DTB

Date: April 23, 2009
 Order No.: S-B-03.30/08i
 Supersedes: S-B-03.30/08h dated October 24, 2008
 Group: 03

SUBJECT: Model 164.156/172/186/871/886
Model 171.454/456
Model 203.052/054/056/087/092
Model 204.054/056/081/987
Model 209.356/372/456/472
Model 211.056/072/087/090/256/287
Model 216.371/386
Model 219.372
Model 221.171/186
Model 230.471
Model 251.156/165
Equipped with M272 or M273 Engine
Check Engine Light On / Fault Codes Current and/or Stored in ME-SFI Control
Module / Oil Leaking at Camshaft Adjustment Solenoid

Figure 1 – Damaged/worn S-B-03.30/08a

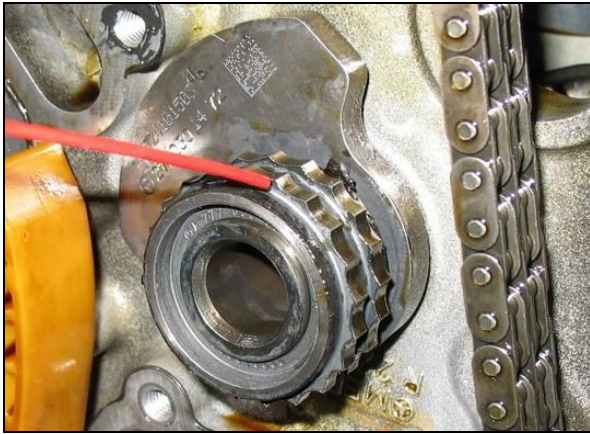
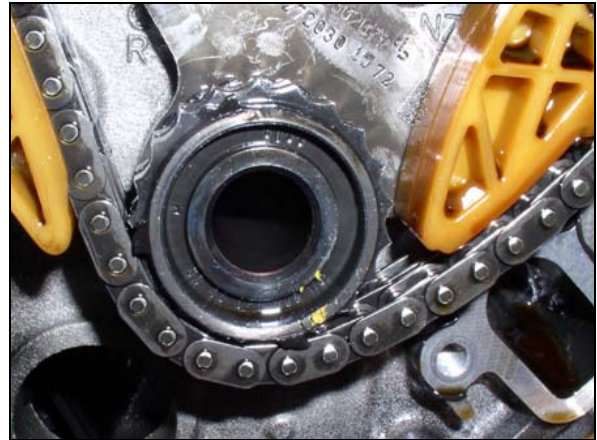
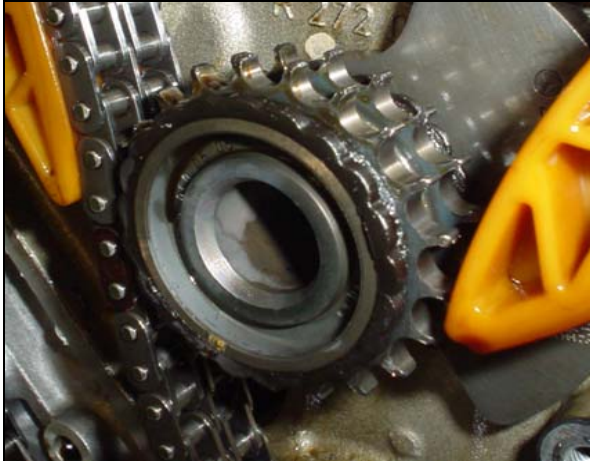
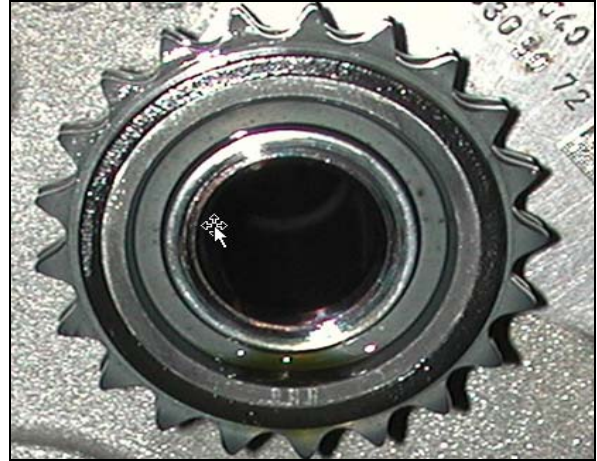
Fault Code Scenario 1: DTC 1200 and/or 1208 is/are present in ME-SFI control module. The fault codes are recorded as current and/or stored in the fault memory. When the fault memory is erased and the engine is restarted, the fault codes reoccur immediately. This is due to the positioning of the timing chain driven camshafts relative to the crankshaft and can be caused by a worn sprocket on the balance shaft on engine M272 or by a worn guide (idler) gear for the timing chain on engine M273. Figure 1, 2 and 3 show extremely worn sprocket gears. Figure 4, for comparison, shows a new sprocket gear.

i **Note:** Refer to Figure 1 through 3 for examples of damaged / worn sprocket profile. Refer to Figure 4 for example of a new gear (for comparison).

- a) Perform a visual inspection for any wear of the teeth (damage profile) on the sprocket of the balance shaft (M272) or of the guide (idler) gear for timing chain (M273) by removing the timing case cover on the engine. Refer to WIS instructions AR01.40-P-8000* (* - applies to a specific model designation e.g. AR01.40-P-8000SX – models 221, 216). Ensure the use of the Special Tool W001 589 81 09 00 when removing / installing timing case cover.

- b) Only if worn (sprocket teeth profile damaged), replace the balance shaft on engine M272 or replace the guide (idler) gear of the chain drive on engine M273 as per WIS instructions AR03.20-P-1000* (* - applies to a specific model designation e.g. AR03.20-P-1000VA – model 171).

Figure 5

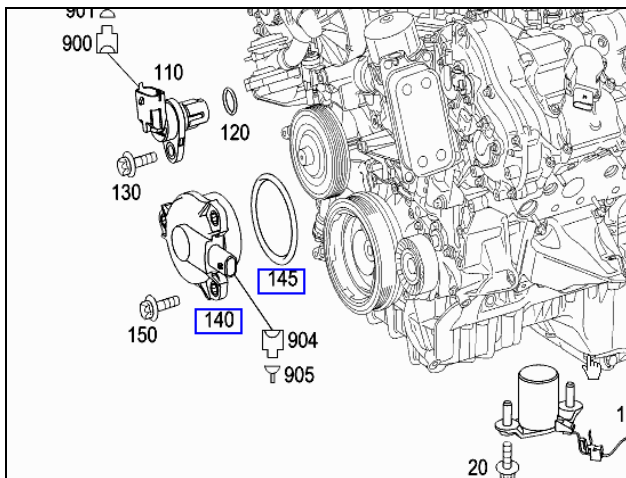
Fault Scenario 3: Camshaft adjustment solenoid is leaking oil, and no Fault Codes are current or stored in the ME Control Module. Determine the cause of the leak. The solenoid can be leaking from under the sealing ring or through the harness connector.

- a) If the leak appears to be between the solenoid and the cylinder head replace solenoid sealing ring (Figure 5, 145).
- b) If the leak is from the electrical connector, replace the solenoid (Figure 5, 140).
